RBG-47211

SUBJECT: Response to Request for Information
Changes to Technical Specification 3.3.6.1, "Primary Containment and
Drywell Isolation Instrumentation"
River Bend Station, Unit 1
Docket No. 50-458
License No. NPF-47

Response to Request for Information

North Steam Tunnel Temperature

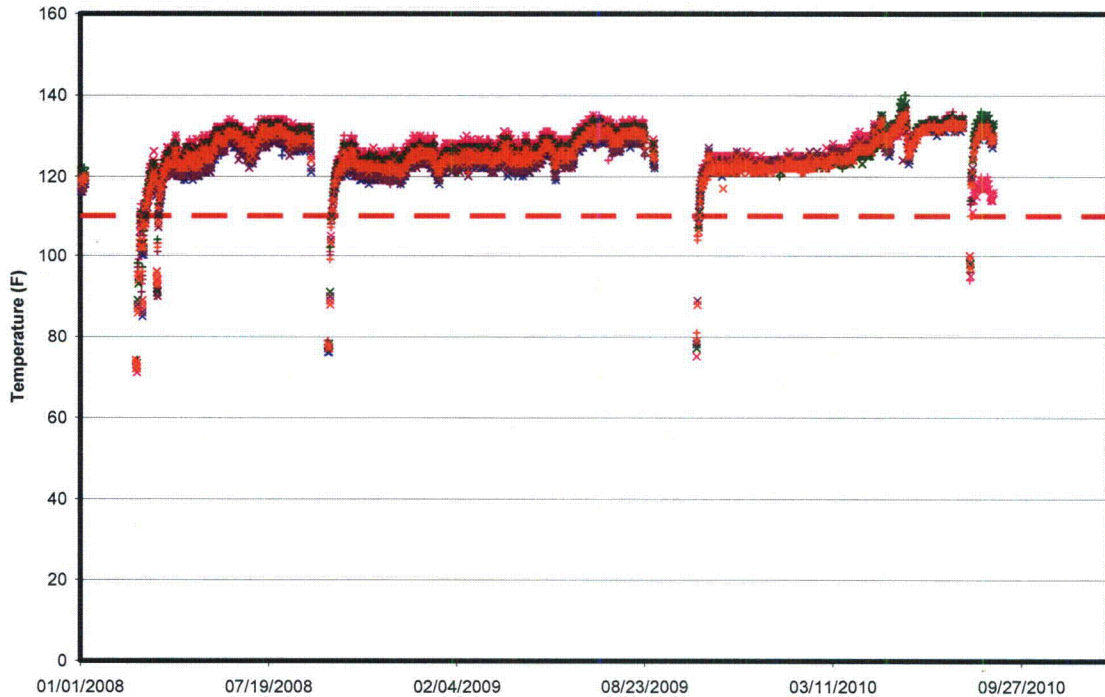
2. Attachment 1, Section 3.0 of the LAR (ADAMS Accession No. ML11214A093) explains that River Bend Station (RBS) has determined that during the summer months the main steam tunnel temperature high alarm has reached the trip setpoints. Please provide a summary of the data collected, including the time duration and the receipt of the high temperature alarms.

The following figure summarizes the north steam tunnel temperatures over the period from January 2008 to August 2010. The large dips in area temperature coincide with large decreases in reactor power. The data was taken from the daily operating logs with readings taken during day and night shifts.
